BEFORE THE PUBLIC SERVICE COMMISSION
OF THE STATE OF MISSOURI

In re: Union Electric Company's 2014)	
Utility Resource Filing Pursuant to)	Case No. ER-2015-0084
4 CSR 240 – Chapter 22)

NRDC's Comments on Ameren's 2015 IRP

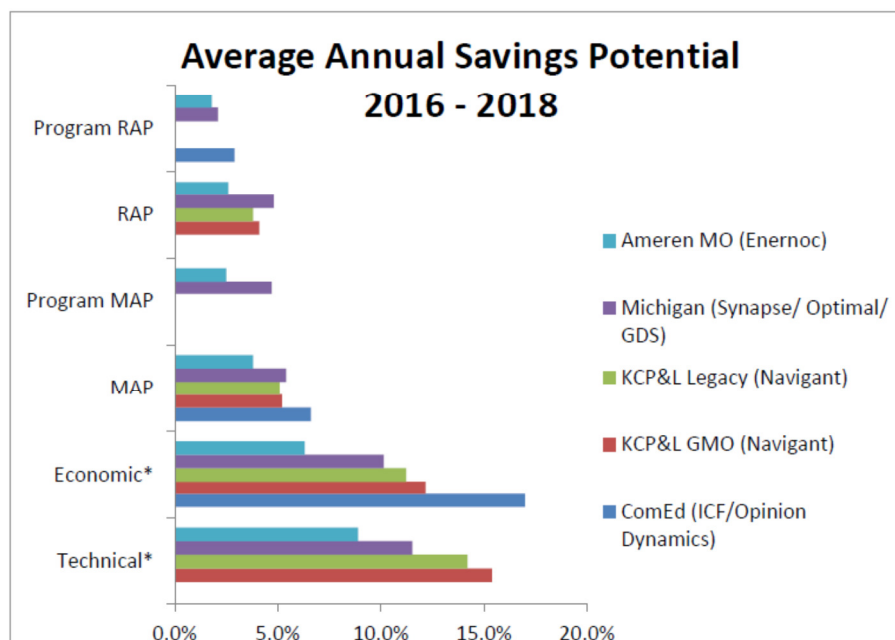
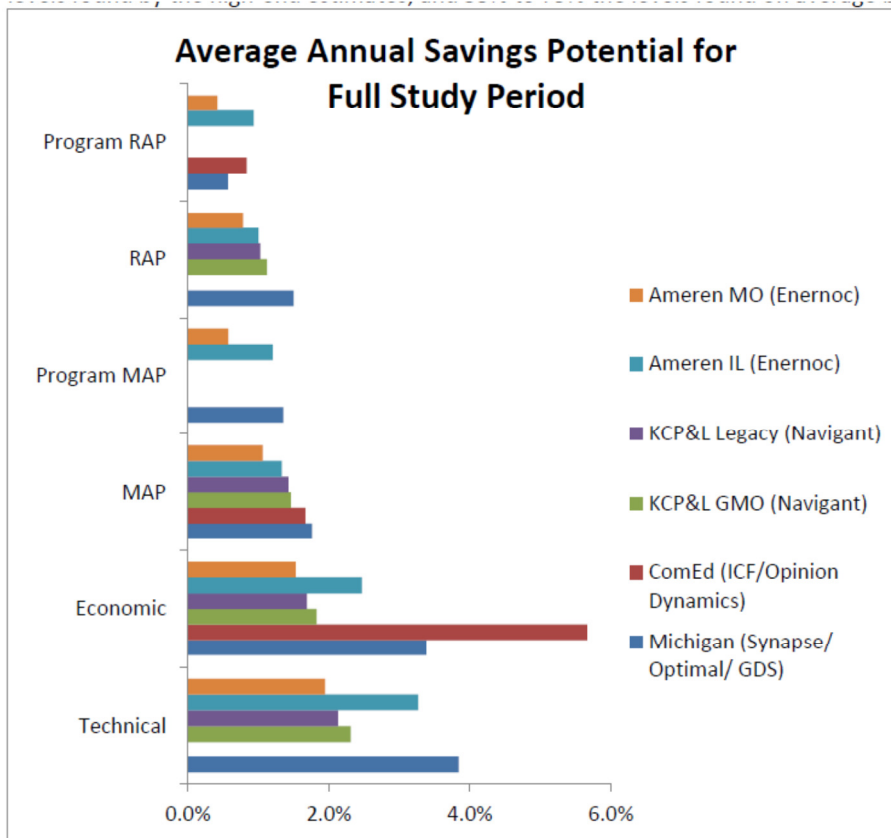
In addition to producing savings estimates significantly lower than results actually achieved in other states, the EnerNOC study finds significantly lower potential than other recent studies performed in the Midwest. In Table 6.2 of Volume 3, Ameren Missouri’s study estimates that the cumulative program level “maximum” achievable savings (MAP) by 2030 is 8.6% and that a more “realistic” level of savings by 2030 is 6.3%. For the RAP scenario, this represents an annual additional savings of approximately 0.4% of baseline consumption. For MAP, the study assumes 0.5% annual savings.

For purposes of comparison, the results of recent similar potential studies are in the charts below. These charts provide a comparison of recent potential study estimates in nearby jurisdictions. As the chart suggests, Ameren Missouri’s estimates of annual savings are less than other recent potential studies. In comparing these studies, high end assessments found cumulative savings potentials between 166% to 371% of EnerNOC’s estimated potential. On average, the EnerNOC study found a potential of only 65% of other state studies. Comparing only Ameren Missouri’s 2016-2018 MEEIA plan cycle with other states’ studies, the EnerNOC study estimates potential of 37% to 62% of the levels found by the high-end estimates of its peers and 55% to 79% of the average levels.

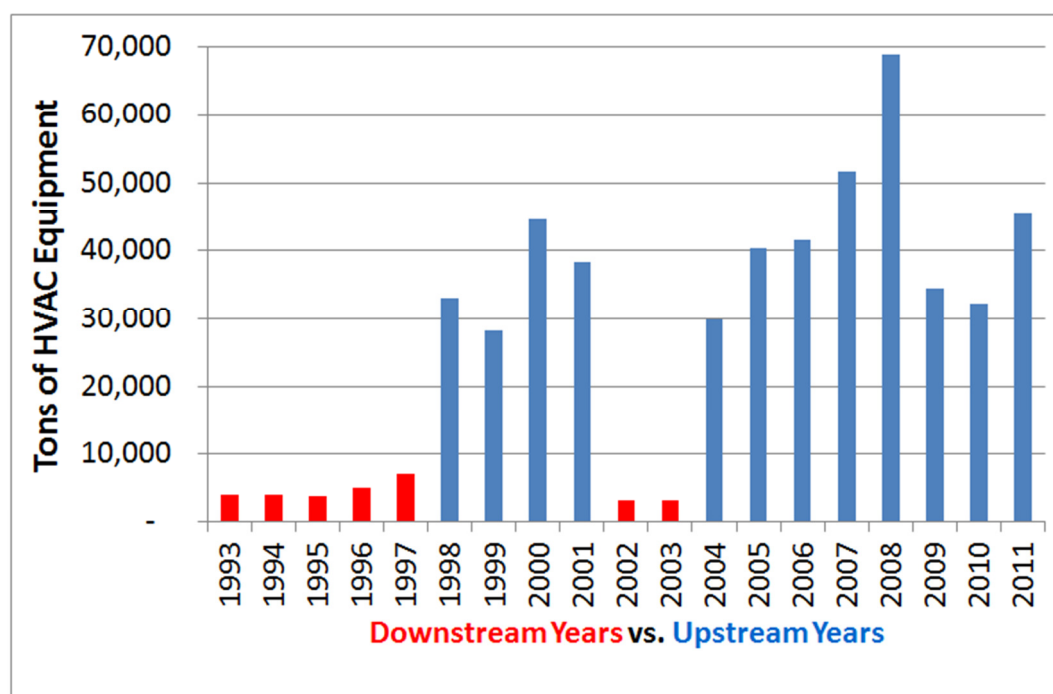
Further, it does not appear that the potential study looked at alternate ways to increase take rates. For example, experience in other jurisdictions indicates that upstream programs significantly increase program participation. The graph below plots a Southern California HVAC program as it moved from downstream to upstream, back to downstream, and then back to upstream.¹⁴

As seen, participation is an order of magnitude higher during upstream years. By not taking into account various program design ideas to increase take rates, such as upstream programs, EnerNOC is significantly underestimating the true potential.
